WHITE PLAINS CITY SCHOOL DISTRICT
RENOVATIONS AT ROCHAMBEAU ALTERNATIVE HIGH SCHOOL
SED Control Number: 66-22-00-01-0-015-020

CONTRACT G – GENERAL CONSTRUCTION WORK
CONTRACT W- WINDOW REPLACEMENT
CONTRACT P – PLUMBING WORK
CONTRACT M – HEATING, VENTILATION, AND AIR CONDITIONING
CONTRACT E – ELECTRICAL WORK

CLARIFICATION TO PROJECT:

DRAWING No. **A 100.00**

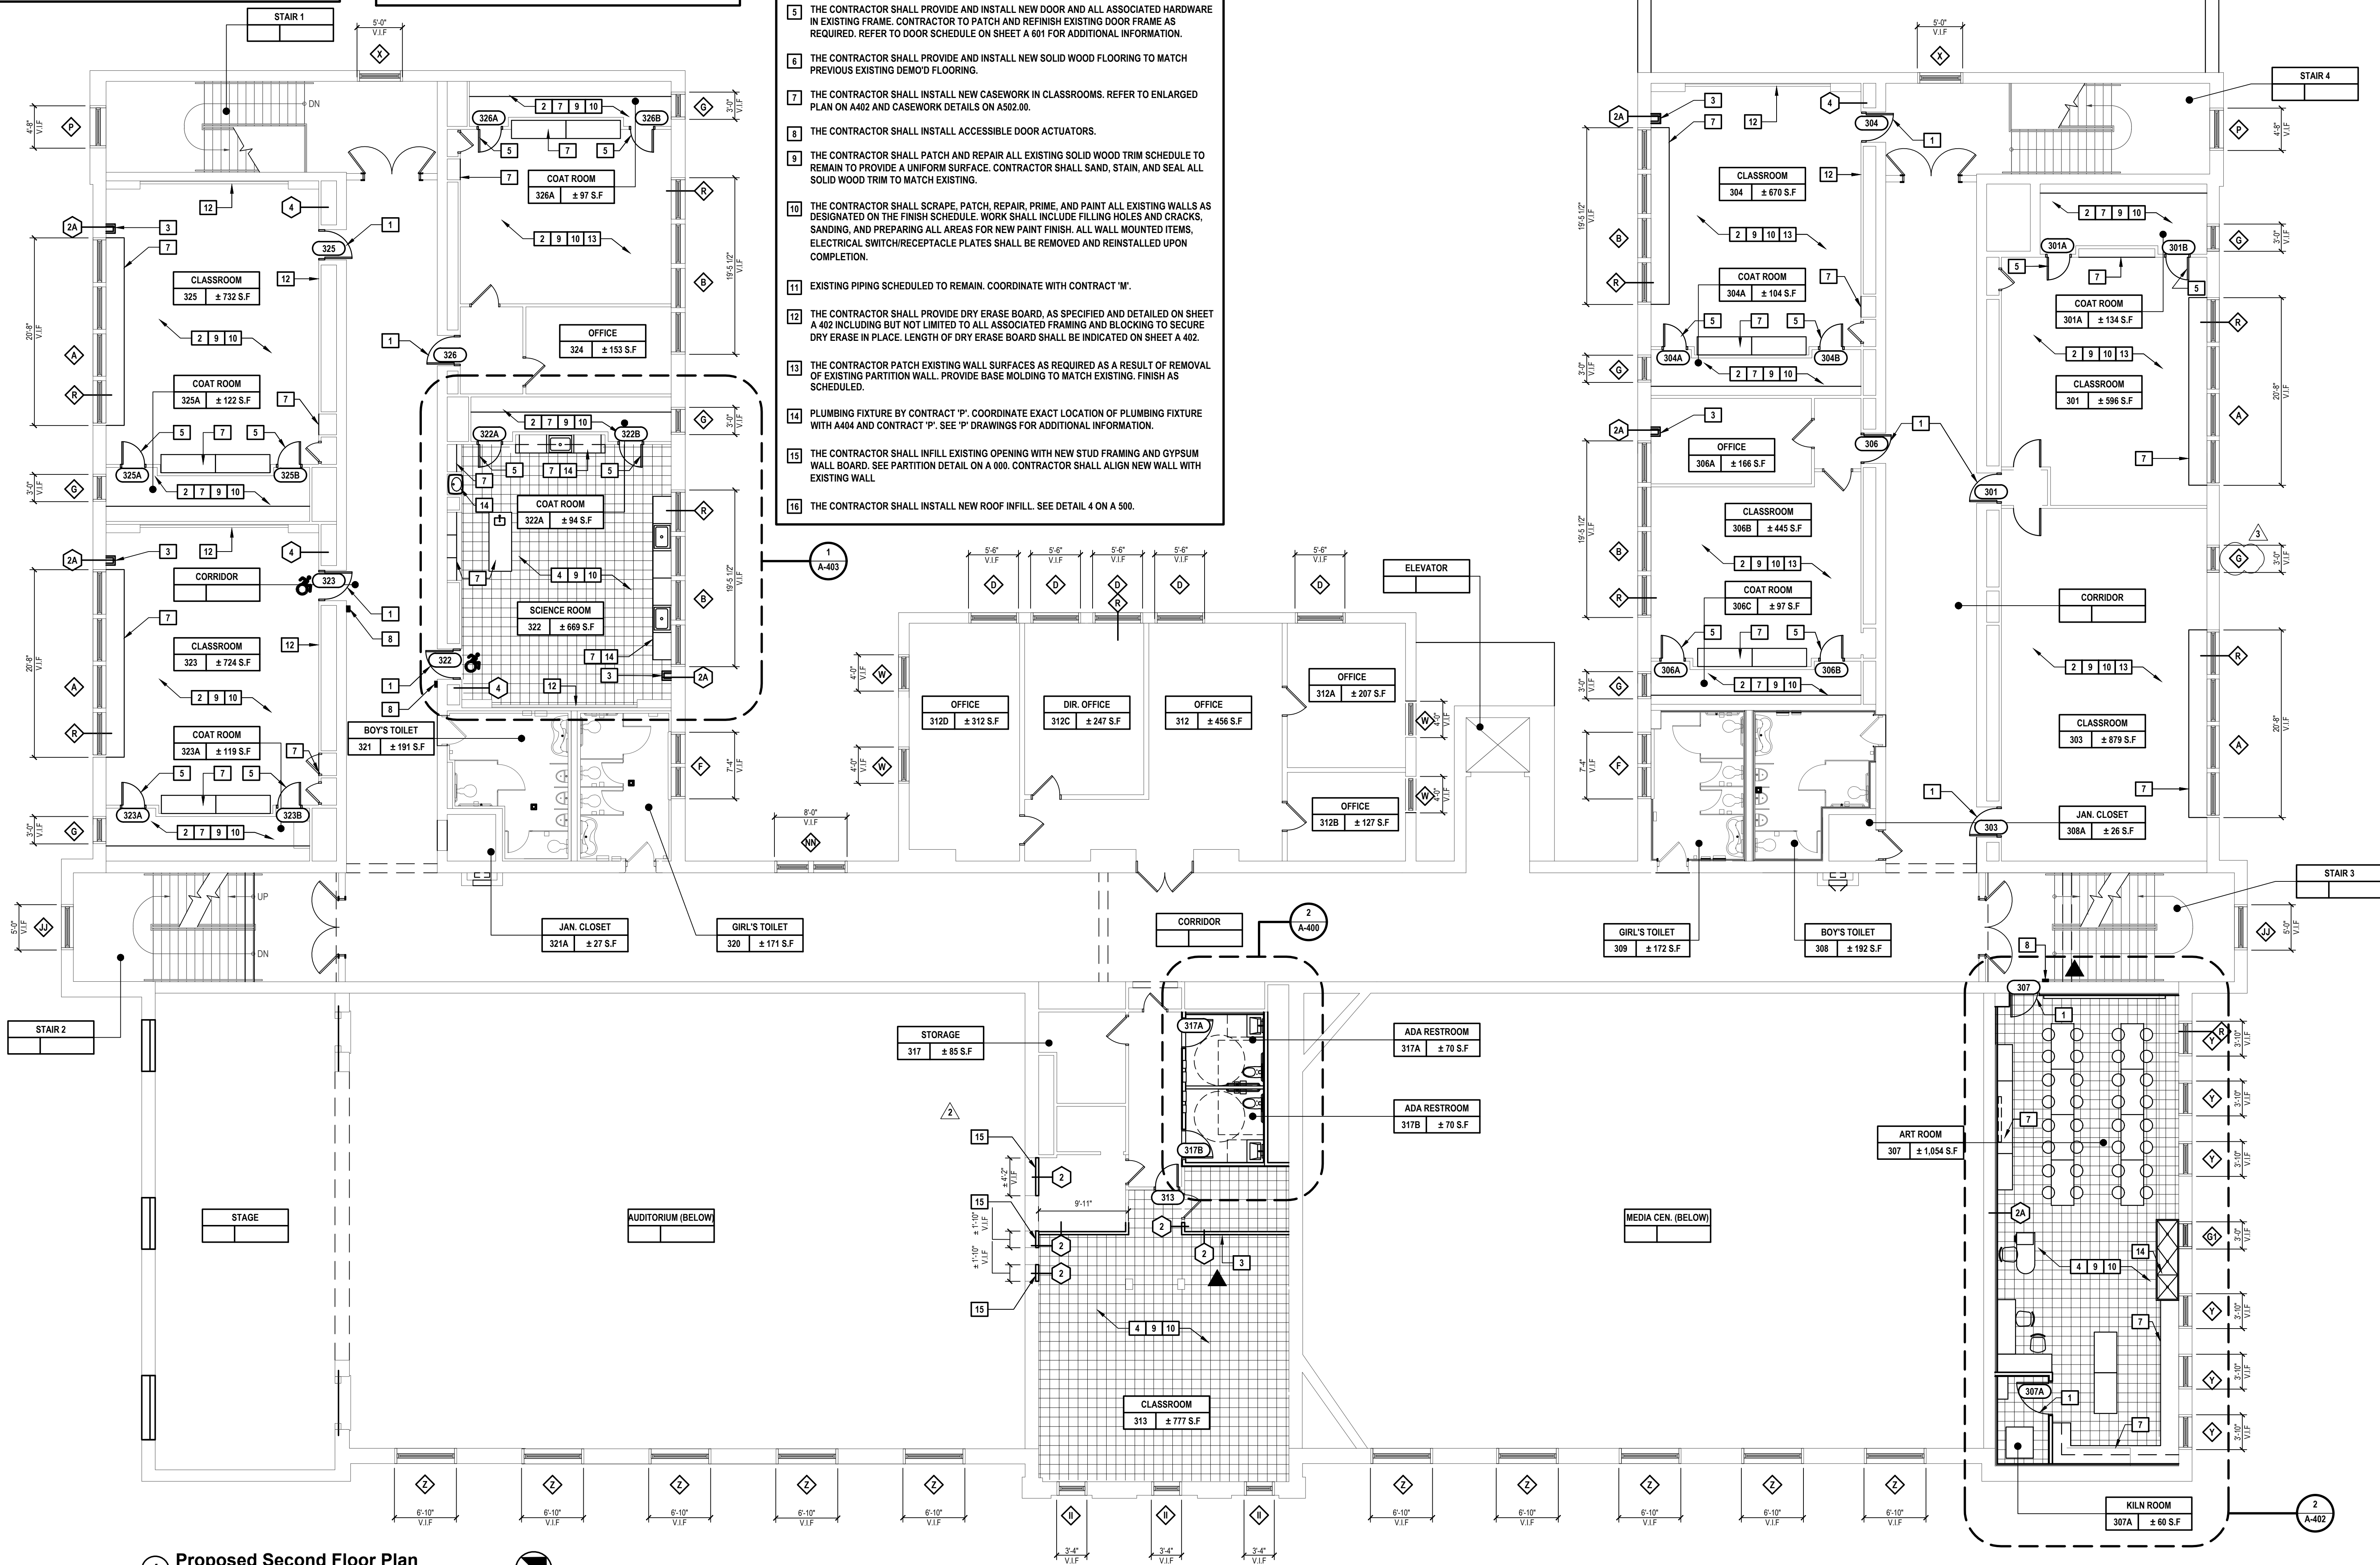
20. *"Page A-600:"*
 - a. *"Window type V and type W are listed twice. Please clarify." **Duplicate window types removed from drawing sheet.***
21. *"Floor plan A-100 Room Office B2- Missing the U1 Window tag. This window is shown on elevation 2/A202. Please clarify". **Window tag U1 provided on A100.00 floor plan.***

- Please clarify scope for windows in louvers. **Contract W shall purchase and install louvers. Louvers shall be glazed into window system.**
28. Page A100 General Work Note 11, window details A500 and window schedule A601 indicates provide new window shades, please clarify which contract this is under.

- If under window contract, please clarify attachment/installation detail shown at new ceiling on 1/A500 and BA601. **Window shades shall be Contract G.**

1. Remove A100.00 PROPOSED BASEMENT FLOOR PLAN and replace with A100.00 PROPOSED BASEMENT FLOOR PLAN. Window type 'U1' has been added to Office B2.
2. Remove A103.00 PROPOSED SECOND FLOOR PLAN and replace with A103.00 PROPOSED SECOND FLOOR PLAN. Window tag 'G' has been added to Classroom 303.

1 Skylight Details

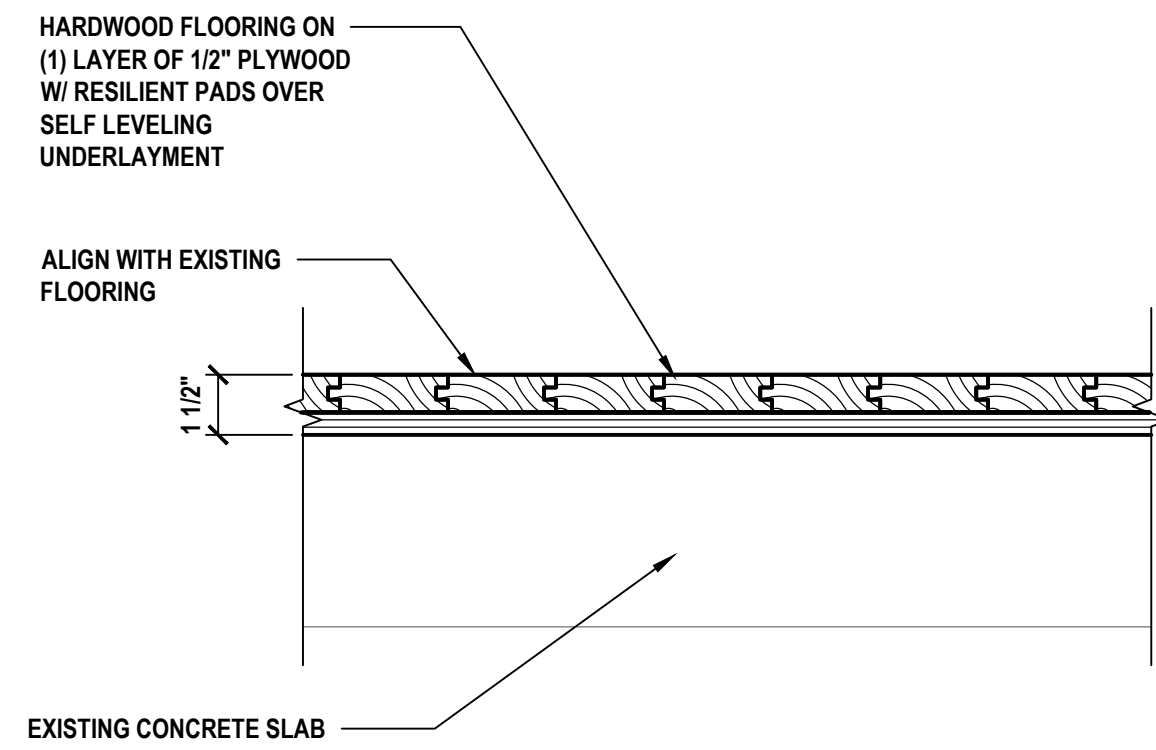
11. *“Dwg A-501 calls out our Pinnacle 900 polycarbonate glazed 9 inch rafter system. The basis of design in the spec*

is our Pinnacle 600 6 inch glass system. Meanwhile, since these are only 11'-ish wide, VELUX can easily provide our Pinnacle 350 3.5 inch system for either/or. Please see typical details for all three models in the insulating glass option attached, since glass is being specified". 6" glass system will be the Basis of Design. Drawings Sheet A501 has been updated. Substitutions must follow the process outlined in the project manual.

3. Remove A501.00 SKYLIGHT AND MISCELLANEOUS DETAILS and replace with A501.00 SKYLIGHT AND MISCELLANEOUS DETAILS. Pinnacle 900 Ridge Member has been revised to Pinnacle 600 Ridge Member. Roof penetration details have been added to the sheet.

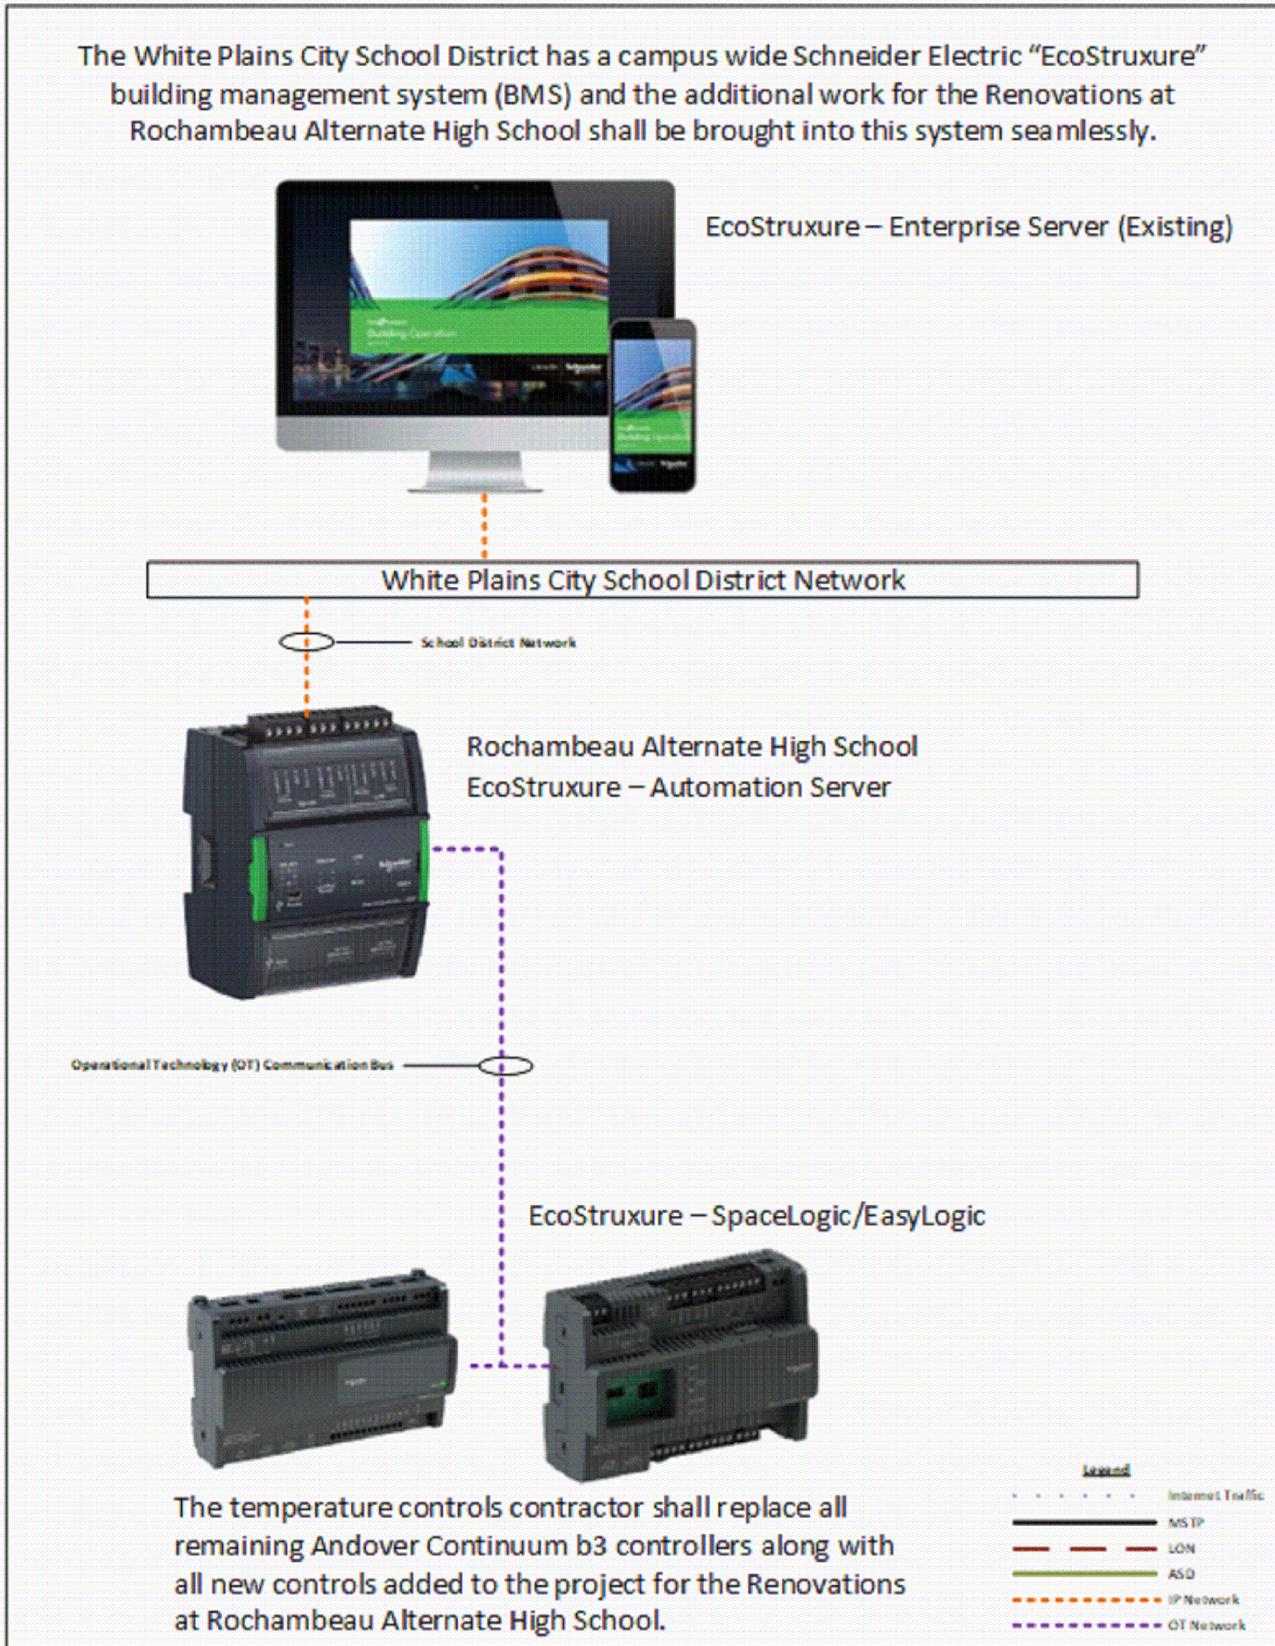
17. *Louver specification indicates 6-inch louver by Airolite with a 1-inch insulated blank off panel and bird screen. Window detail A1 page A 601 shows a 2-inch louver with no insulated blank off panel. Please clarify louver specification for glazed in window louver. **Specification Section 085113 now includes a section for glazed in louver.***

10. Remove M600.00 MECHANICAL SCHEDULE (1 OF 2) and replace with M600.01 MECHANICAL SCHEDULE (1 OF 2). Note #4 "SCHEDULE FOR REFERENCE ONLY. LOUVER PROVIDED AND INSTALLED BY CONTRACT 'W'. CONTRACT 'M' TO COORDINATE WITH CONTRACT 'W'" added to Louver Schedule.
